Report of Roof System Condition Assessment

Incubator Building – North Roof Area Removal
6345 Grand Blvd.
New Port Richey, FL 34652

BillerReinhart Project No. 16-502

**Subject: Report of Roof System Condition Survey
Incubator Building – North Roof Area Removal
6345 Grand Blvd.
New Port Richey, FL 34652
BillerReinhart Project No. 16-502**

Figure A-3

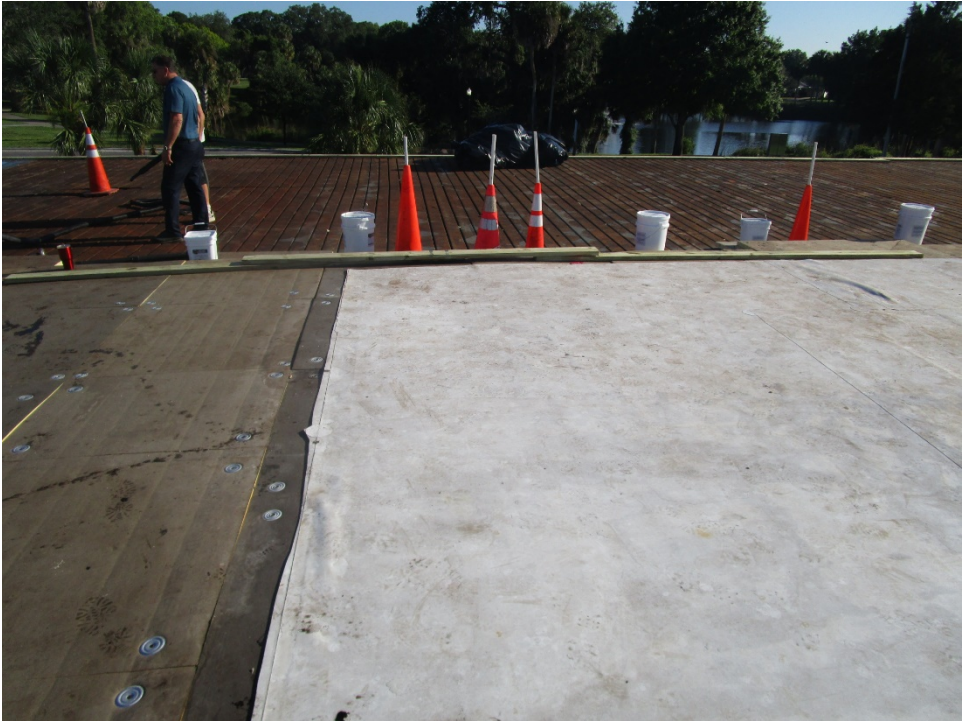
1. Inadequate spacing of roof system fasteners along the building perimeter zones. Fastener markings were not utilized to space fasteners at 6 inches on center. Fasteners were spaced at approximately 12 inches on center (Figures A-1, A-2, A-3, and A-12).
2. Inadequate spacing of roof system fasteners within the field of the roof. Fastener markings were not utilized to space fasteners at 12 inches on center. Fastener spacing exceeded 12 inches on center (Figure A-13).
3. Lengthwise roof membrane seams were installed parallel to metal roof deck flutes. The membrane should have been installed perpendicular to the roof deck span to distribute wind forces over multiple roof deck panels (Figure A-4).

Figure A-9

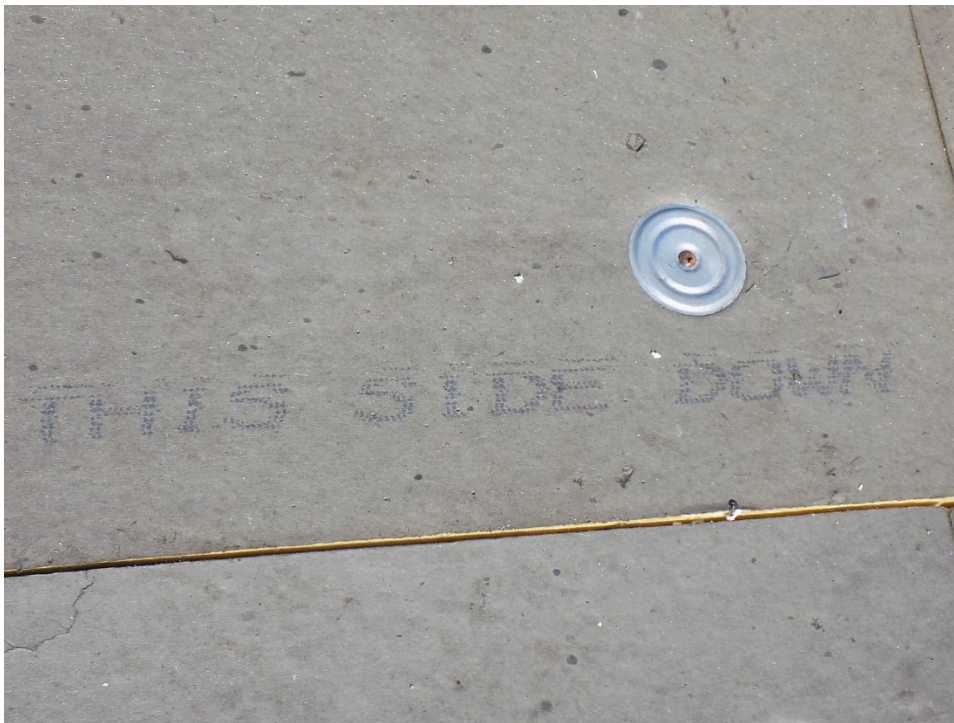
5. The roof membrane was installed over the perimeter detailing from a prior roof system. The perimeter detailing consisted of ½” plywood over an older built-up roof system (Figures A-8, A-9, and A-14).

Figure A-27

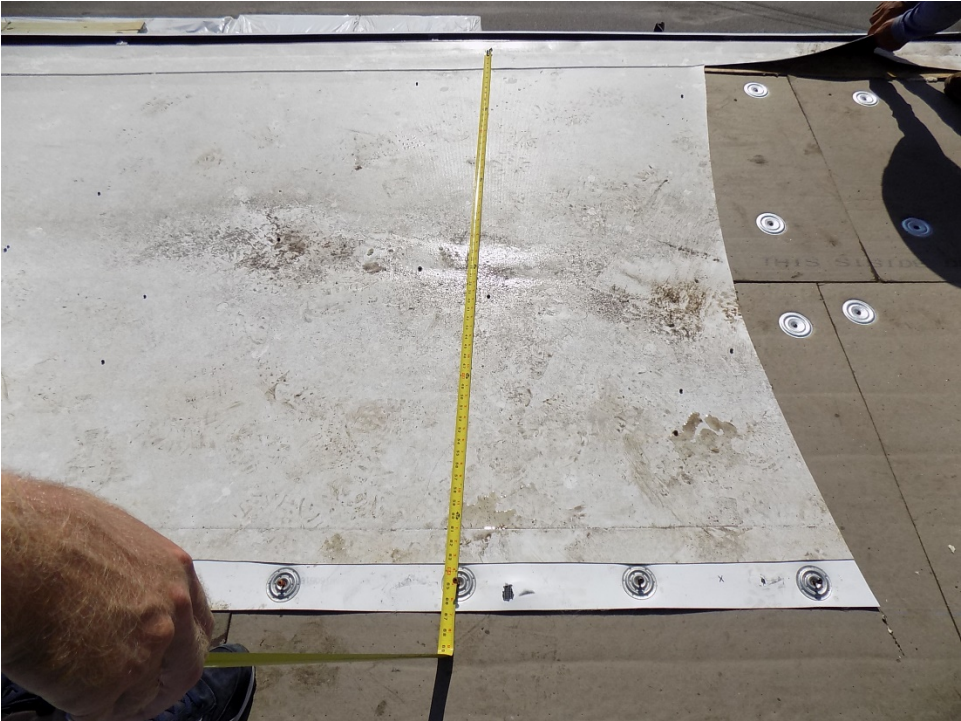
15. Water staining on insulation panel surfaces indicative of moisture intrusion (Figures A-27 and A-31).
16. Excessive distance between roof perimeter and first row of roof system fasteners (Figures A-28 and A-29).

Figure A-37

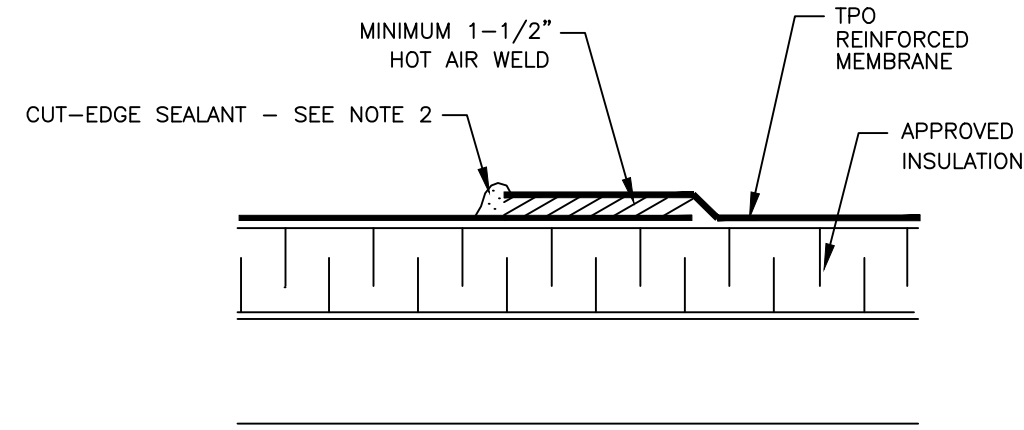
23. Insulation panels spanned over open space between underlying insulation panels and shim pieces – attempt to create a roof surface slope while accommodating for missing tapered panels (Figure A-34).
24. Board and insulation panel shims along roof perimeter (Figures A-35 and A-36).
25. The existing expansion joint utilized tapered wood blocking over older flat wood blocking. Wood segments were utilized within the expansion joint space to fasten the tapered wood blocking, thus reducing the expansion joint's ability to contract during temperature changes (Figure A-37).
